SUBJECT: Requests assistance in resolution of applicable codes for containment penetration grout hole closure detail. Related details & drawing encl.

SHEARON HARRIS NUCLEAR POWER PLANT UNIT NOS. 1, 2, 3 AND 4  
DOCKET NOS. 50-400, 50-401, 50-402, AND 50-403  
CONTAINMENT PENETRATION GROUT HOLE CLOSURE DETAIL

SHEARON HARRIS NUCLEAR POWER PLANT  
CONCRETE GROUT HOLES IN PENETRATIONS

SHEARON HARRIS NUCLEAR POWER PLANT CONTAINMENT LINER

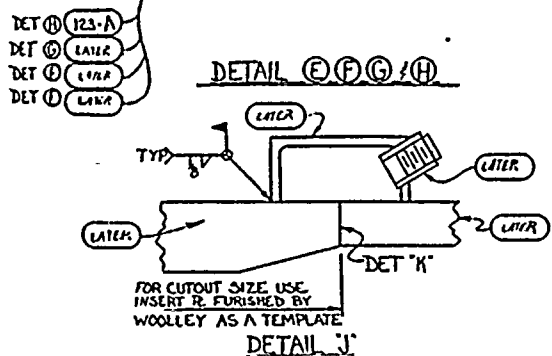
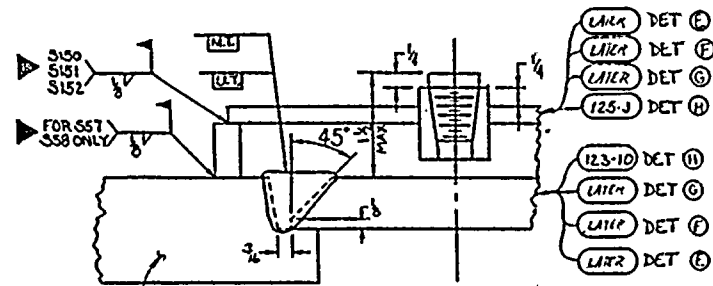
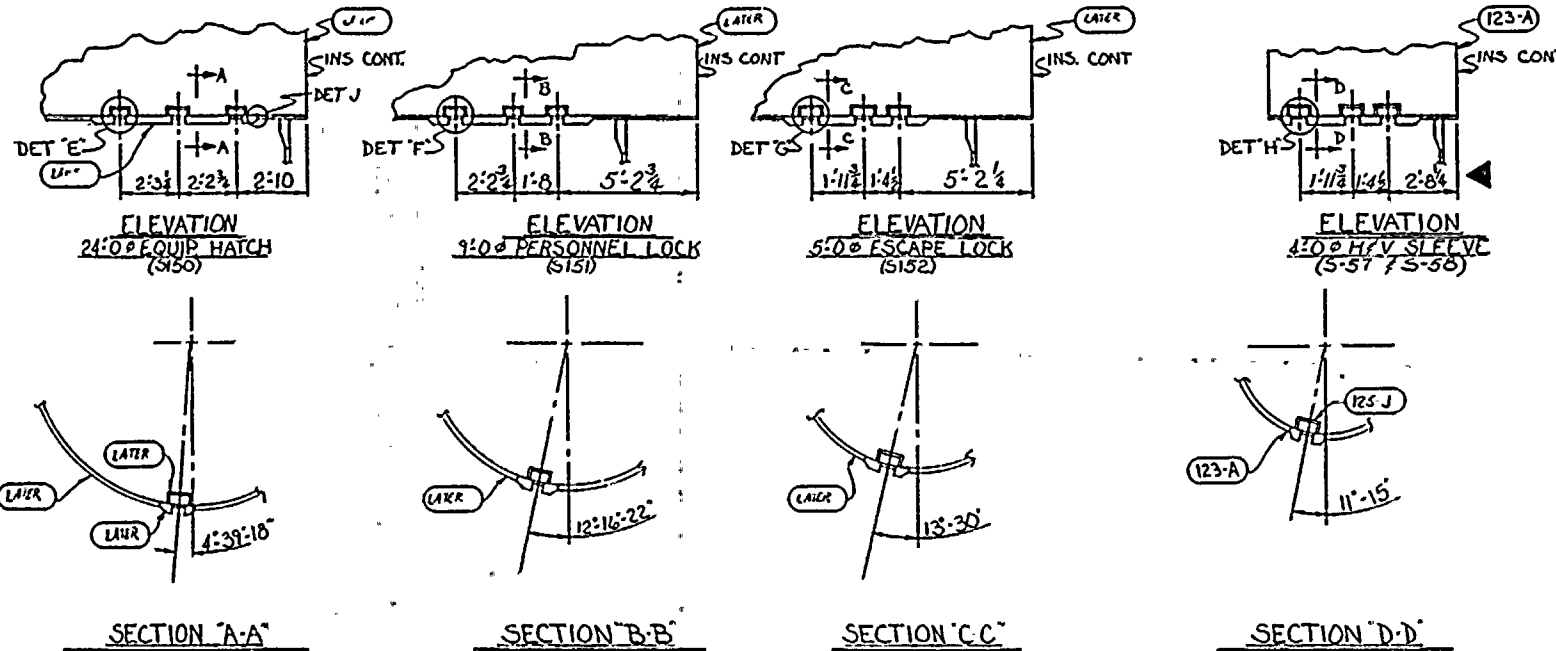
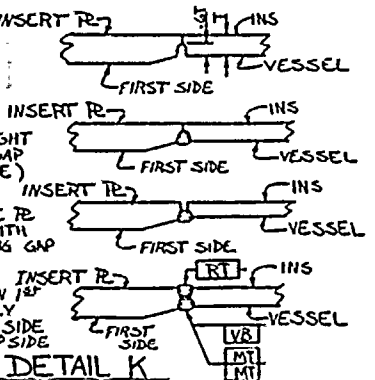
During a constructability review of the Unit No. 1 containment exterior wall, members of my staff concluded that special precautions would be necessary to ensure proper consolidation of concrete under the larger containment penetrations with dense supplementary reinforcing steel around them. It was concluded that it would be prudent to have holes in the bottom of each of these penetrations to facilitate insertion of vibrators. Chicago Bridge & Iron Company Drawing 27, Revision 1 is attached as Enclosure (1) and shows the related details for penetrations S-57, S-58, S-150, S-151, and S-152. As can be seen, the closure weld detail requires ultrasonic and magnetic particle examination.

Problem Area; 3 small 4" diameter holes, in a row in bottom of penetrations to facilitate concrete pour to ensure sound area under each penetration.

Code: No weld type joint specifically shown on vessel illustration, Fig. NE 3351-1 for Category A,B,C,D, weld joints which are similiar to closure plate for the holes.

The penetration components were redesigned to add thicker plate in hole areas for reinforcement such as openings. A hole 4" diameter cut through and counterbored to provide a lip to act as a backing for closure weld after concrete has been poured.

Design: For compliance with NDE requirements for Category A or B type weld joints by inspecting with UT in lieu of RT for inaccessible welds per Para NE 5211.1

Problem: Para. NE 5211.2 on hydro inspection of Category A and B welds states that examination of embedded or inaccessible welds of containment vessels may be waived if they are double butt welded and fully radiographed prior to covering and are leak tightness tested with a gas medium test such as a halide leak detector test.

- Full penetration butt weld; area reinforced like an opening per code requirements.
- UT inspection per code in lieu of RT.
- Perform gas leak test by leak chase channel.

- Not a code stamped penetration; however, the commitment is to NRC to design and build to code. Design is conservative.
- UT in lieu of RT per NE 5211.1.
